Littelfuse, Inc.  
 8755 West Higgins Road, Suite 500  
 Chicago, IL 60631 USA  
 (773) 628-1000

Feb.28th, 2020

Subject: Datasheet Correction of Littelfuse SIDACTor QFN Package

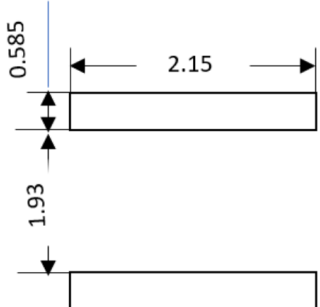
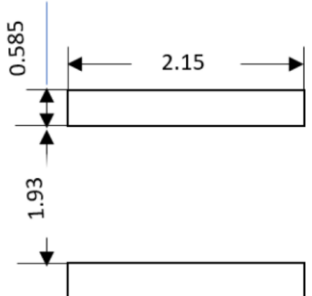
Littelfuse would like to notify you datasheet correction about footprint dimension of SIDACTor QFN package products. There is no any change to physical product itself.

Package	Wrong footprint	Correct footprint
Q2L Series, Pxxx0Q22xLHL Series, -3.3x3.3 QFN	 <p style="text-align: center;">Recommended Soldering Pad Outline (Reference Only)</p>	 <p style="text-align: center;">Recommended Soldering Pad Outline (Reference Only)</p>
Q2L Series - 3x3 QFN	 <p style="text-align: center;">Recommended Soldering Pad Outline (Reference Only)</p>	
PLED Series – QFN	 <p style="text-align: center;">Recommended solder pad layout (Reference Only)</p>
